Annex 3.6 to the Applicant's response to Relevant Representations from Natural England (RR-026.E.7)

Deadline: Procedural Deadline Application Reference: EN010136 Document Number: MRCNS-J3303-RPS-10129 Document Reference: S_PD_3.6 27 August 2024 F01

1 Applicant's response to Relevant Representation from Natural England: Fish and Shellfish (RR-026.E.7)

Figure 1: Modelled TTS ranges for fish with European sites designated for Annex II diadromous fish (single piling, 4,400 kJ hammer energy, north piling location).

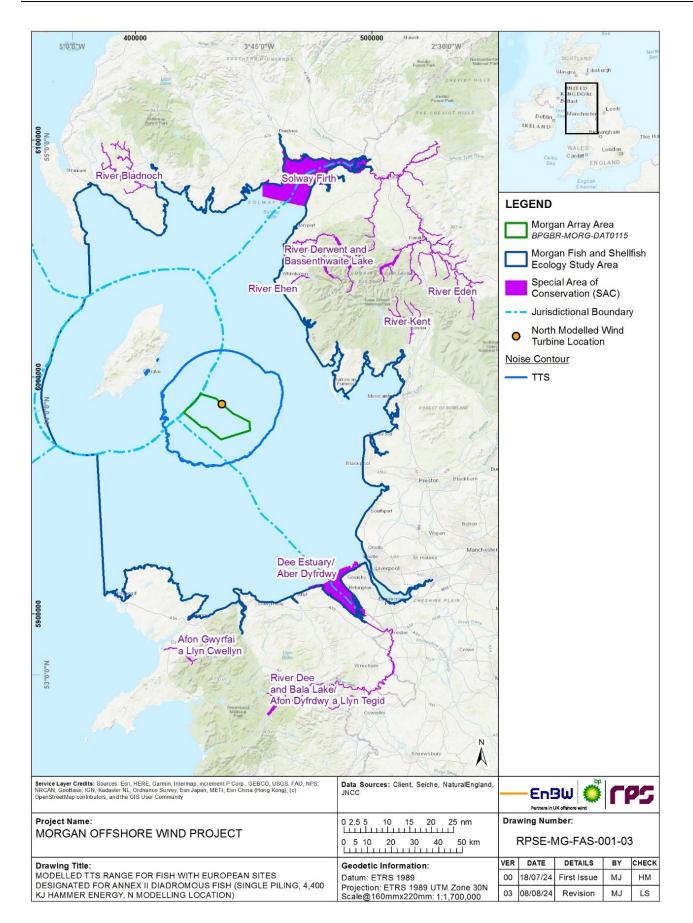
1.1.1.3 Further to the above comment, whilst it is useful to display TTS range (23,900m) for fish in a tabular format, it would be more useful to have a site contour map displaying the array red line boundary, designated sites and this range to allow Natural England to visually assess proximity to protected sites more easily.

1.1.1.4 *Provide a contour map for TTS range.*

- 1.2.1.1 Contour maps for the modelled Temporary Threshold Shift (TTS) range of 23,900 m are provided for the north and west piling locations in Figure 1 and Figure 2, based upon a TTS threshold of 186 dB re 1 μPa²s (cumulative Sound Exposure Level; SEL_{cum}).
- 1.2.1.2 Figure 1 and Figure 2 show the relevant designated sites for Annex II fish based upon those sites considered within the Habitats Regulations Assessment (HRA) Stage 1 Screening Report (APP-099) and the HRA Stage 2 Information to support an appropriate assessment Parts 1, 2 and 3 (APP-096 to APP-098).
- 1.2.1.3 There is no overlap with the designated sites assessed under the HRA for Annex II fish by the TTS contour at either modelling location.
